BLM SCALAR FIX -Based on findbhudda's original design:
<http://www.midibox.org/dokuwiki/doku.php?id=findbuddha>

DESIGN FILES:

Corrected blm-scalar v1.1.brd bellow & attached [blm-scalar_v1.1.brd.zip](#)

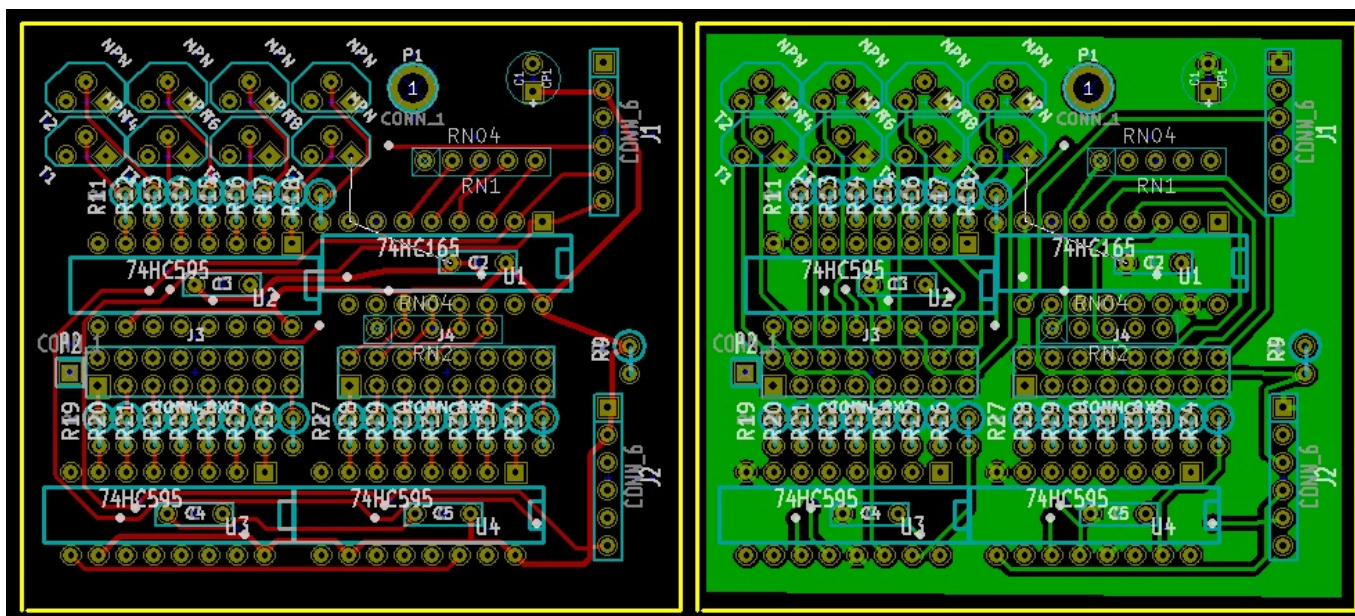
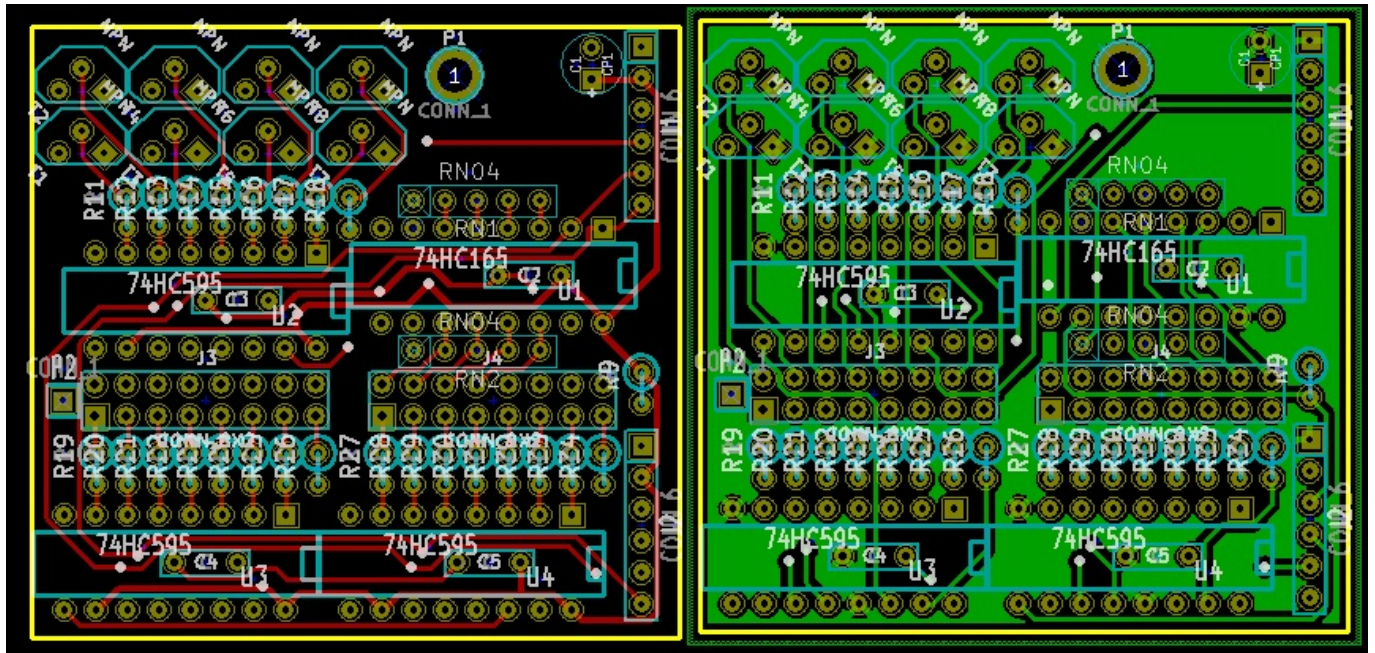
- blm-scalar.* contain an error. Pins I4-I7 are mirrored. This is easily fixed with a connector modification, and the blm-scalar module seems to work as intended.
- blm-scalar v1.1 attempts to fix this error. Moved connectors J1, J2, Resistor Net 1 and R9 to make room for corrections.
